SUBJECT: CLINTON POWER STATION, UNIT NO. 1 - ISSUANCE OF AMENDMENT
NO. 241 RE: REVISION OF DEGRADED VOLTAGE RELAY ALLOWABLE
VALUES (EPID L-2021-LLA-0005)

SAFETY EVALUATION BY THE OFFICE OF NUCLEAR REACTOR REGULATION

CLINTON POWER STATION, UNIT NO. 1

Figure 1: DV ALs & ATSP with associated AVs (Reset & Dropout) relationships

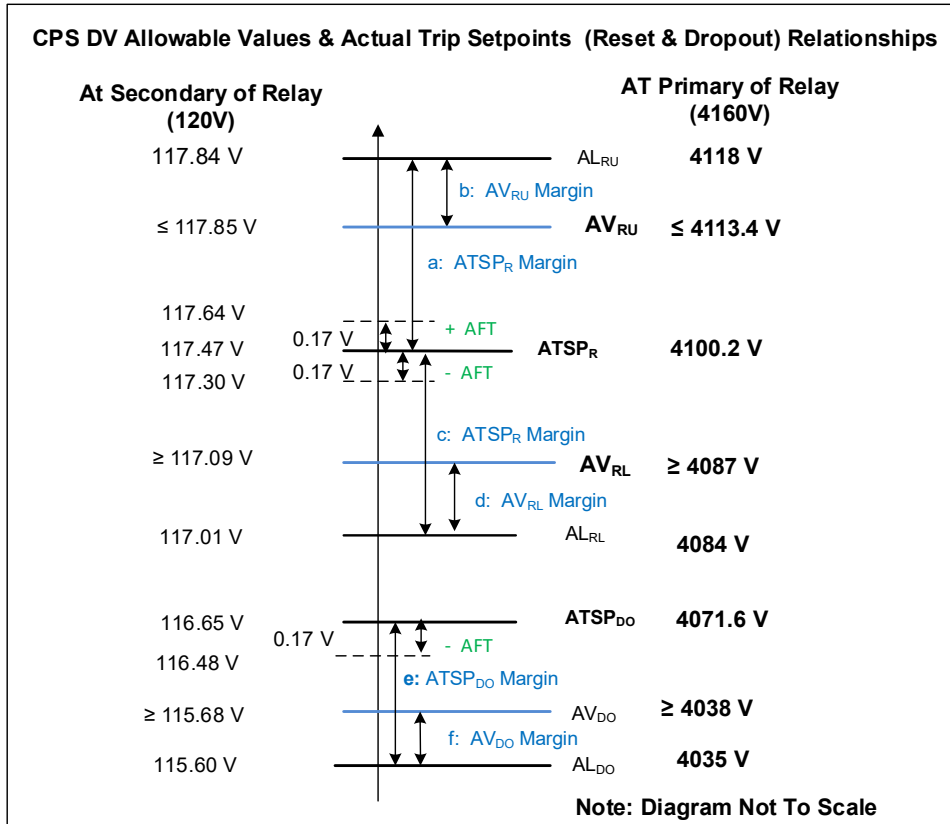
The NRC staff established the relationships between the DV ALs, NTSP, ATSP, and associated AVs of Buses A1_AB; A1_BC; B1_AB; B1_BC; C1_AB; and C1_BC. These relationships are reflected in Figure 1 below:

The NRC staff used the information in Table 1 through Table 3, Figure 1, and the guidance in RG 1.105, Revision 3, to independently calculate the margins between:

- Based on the information in Figure 1, the NRC staff verified that:

$$\begin{aligned} \text{ATSP}_R + \text{AFT} &< \text{AV}_{RU} \\ \text{ATSP}_R - \text{AFT} &> \text{AV}_{RL} \\ \text{ATSP}_{DO} - \text{AFT} &> \text{AV}_{DO} \end{aligned}$$

Therefore, the proposed AVs would assure that the trip signals will be initiated before $ATSP_{RU}$ and $ATSP_{DO}$ reach their AV values.

- Table 2 of this SE shows the AFT value is greater than the ST value. The AFT is greater than or equal to the as-left, or setting, tolerance and the application of the AFT does not result in a violation of an applicable limit. The nearest applicable limit to the ATSP is the AV. Figure 1 shows that the $ATSPs \pm AFT$ do not reach the applicable AV. Therefore, this AFT is acceptable.
